State of Florida
Department of Environmental Regulation
CONVERSATION RECORD

Regarding Perdido Landfill

TO: Cindy W. Anderson, P.E. *C*
THROUGH: Robin M. Bjorklund, P.G. *RMB*
FROM: Richard M. Markey, P.G. *RMM*
DATE: February 18, 1991
SUBJECT: December 1990 and January 1991 Perdido Landfill CA Status Reports - Escambia County

SUBJECT: Interim Remedial Action Plan (IRAP) for Perdido Landfill - Escambia County

FIGURE 5-2.
Reported VOC Concentrations, January 1990.

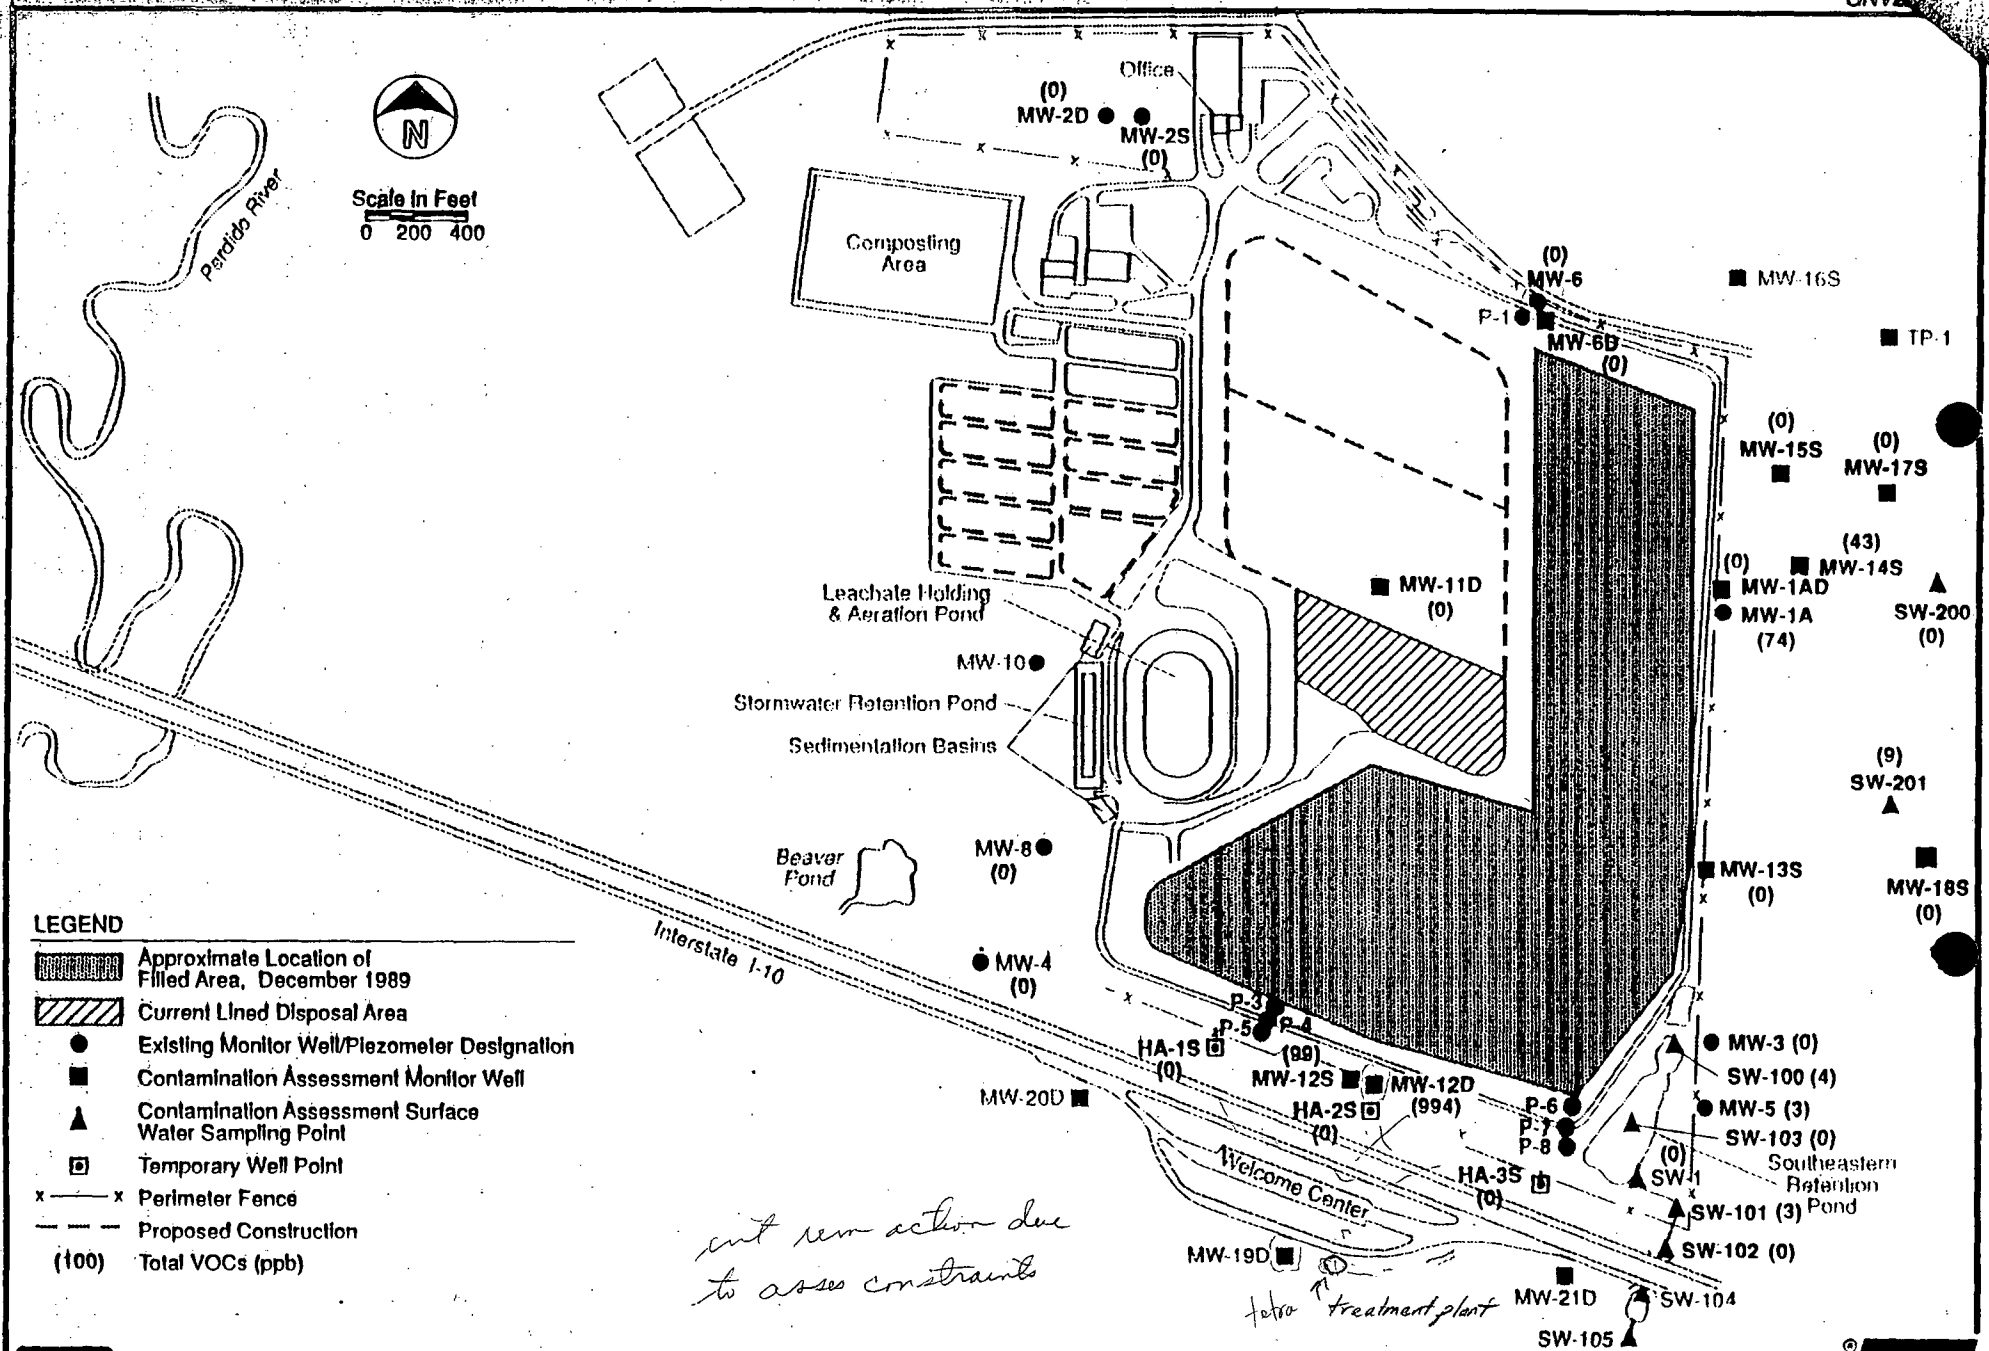
Distance between MW-12D + MW-19D = ~625'

$$dh/dl = .004096 \text{ ft/ft}$$

$$n_e = .20$$

CH₂M Hill Rpt less 1.99 ft/day 12D

PDohms Rpt 65.2 - .51 ft/day = K_h
dated 11/27/90

$$V = \frac{K_h I}{N_e} = \frac{65.2 (.0041)}{.2} = 1.33 \text{ ft/day}$$

$$V = \frac{K_h I}{N_e} = \frac{.51 (.0041)}{.2} = .01 \text{ ft/day}$$

$$V = \frac{K_h I}{N_e} = \frac{17.86 (.0041)}{.2} = .37 \text{ ft/day}$$

$$\text{Ave} = .57 \text{ ft/day} = V$$

$$625 \text{ ft} / .57 \text{ ft/day} = 1096.5 \text{ days} / 365 = 3 \text{ yrs.}$$

FIGURE 4-5. Sand and Gravel Aquifer Groundwater Contours Relative to NGVD, September 1990.

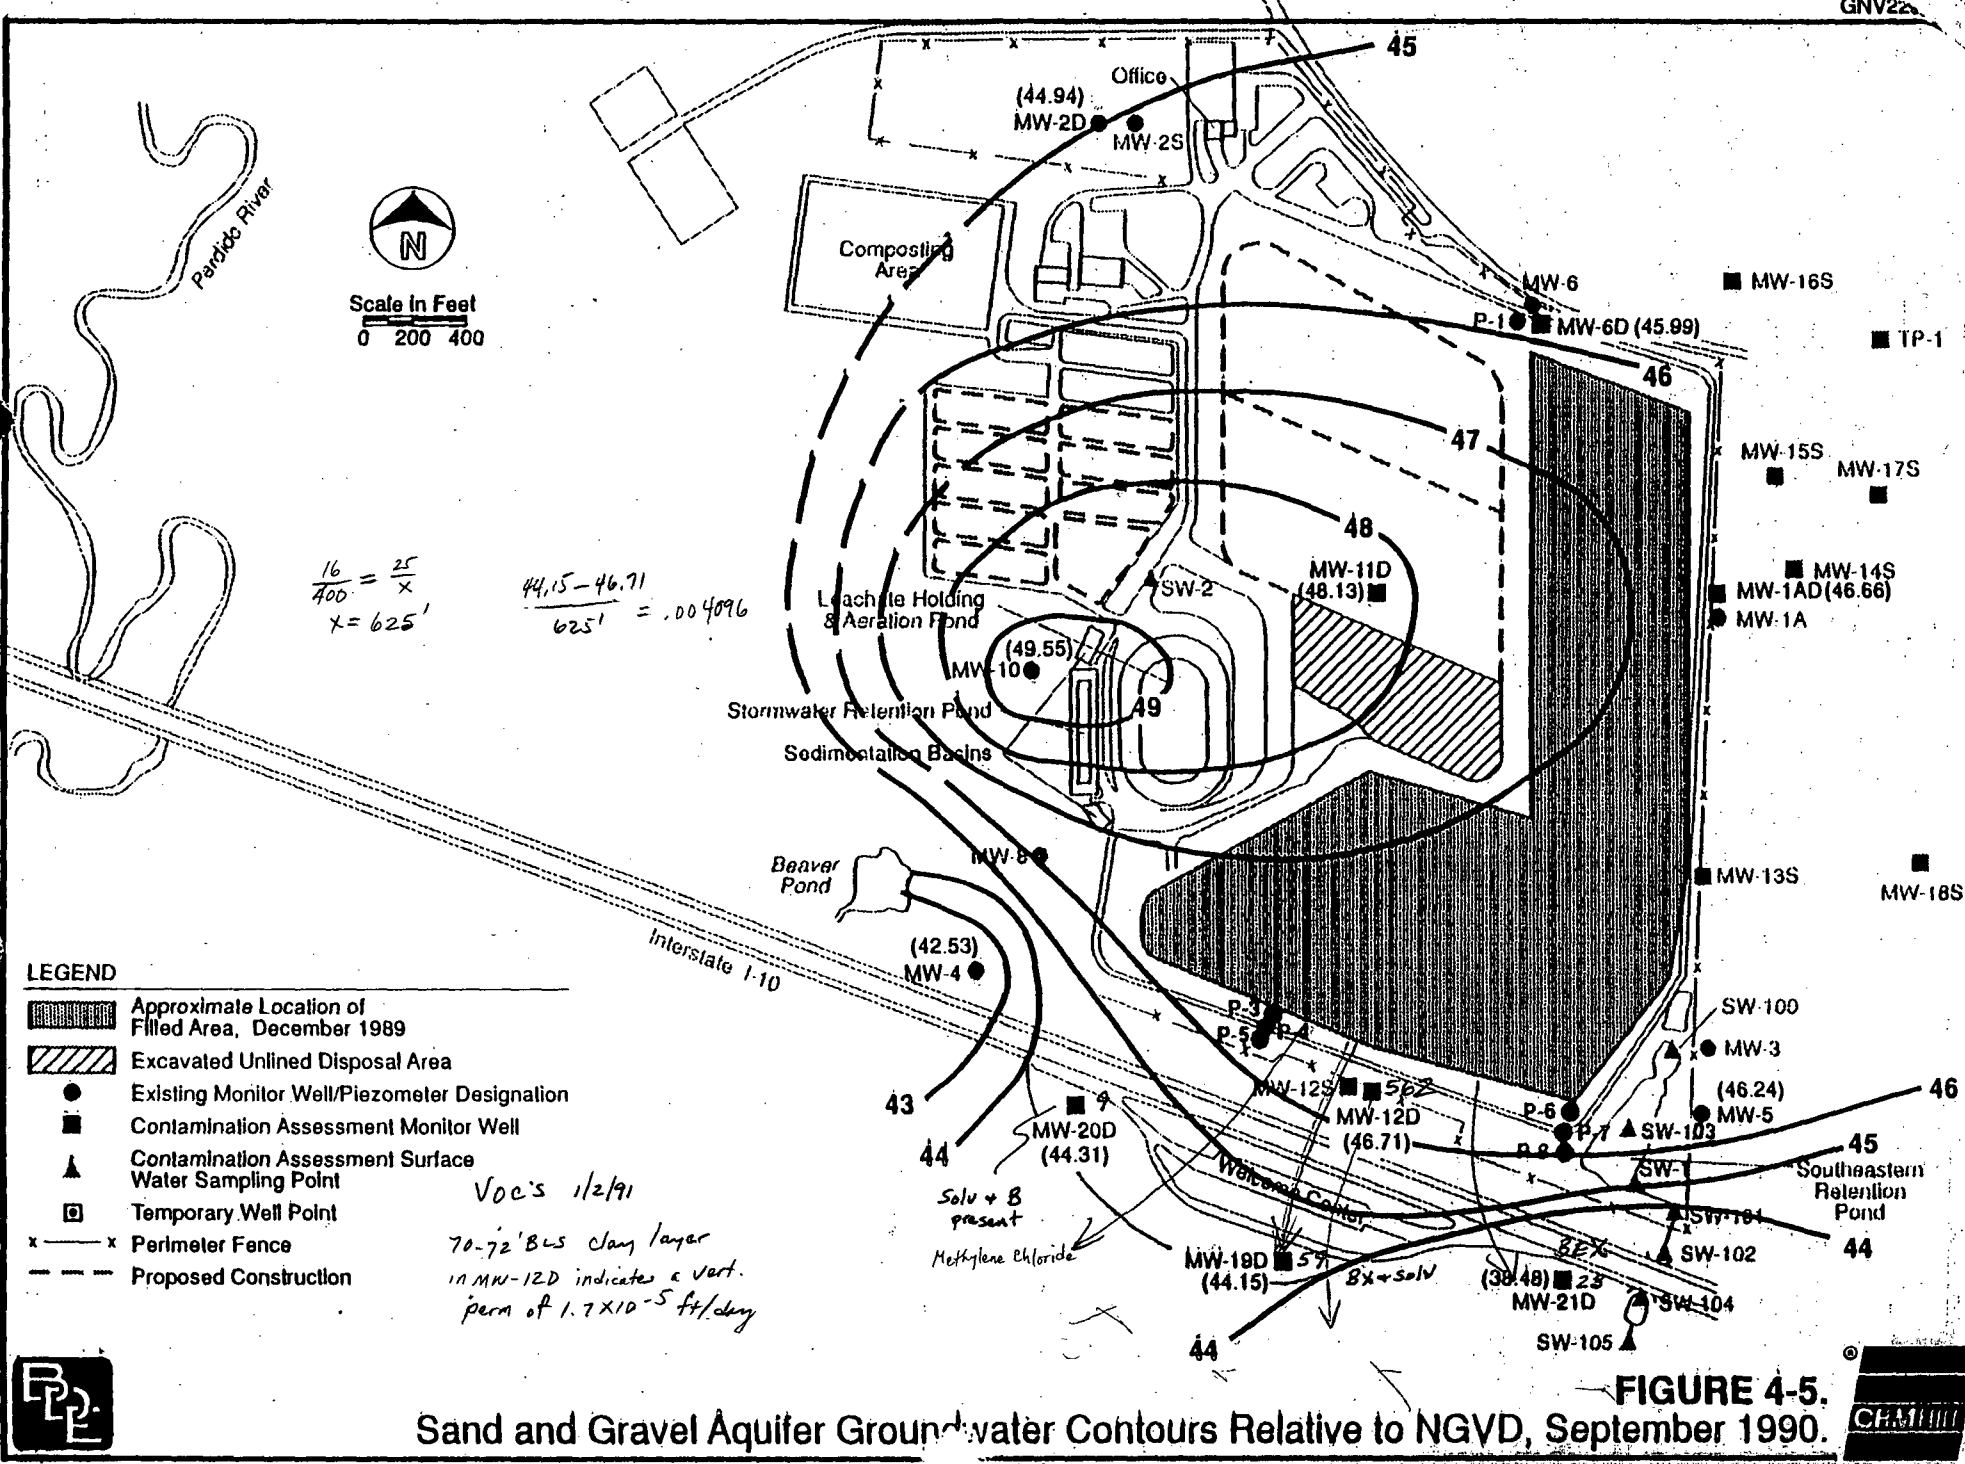
In regard to the potentiometric map (Figure 4-5) submitted by CH2M Hill, this map indicates a potentiometric high in the vicinity of MW-10 and the primary treatment pond. In a telephone conversation with Mr. Peter Dohms, P.G., on January 22, he stated that he had recontoured water levels in this aquifer using additional well data and that his map did not indicate this same configuration. A corrected map should be submitted if the interpretation in Figure 4-5 is incorrect.
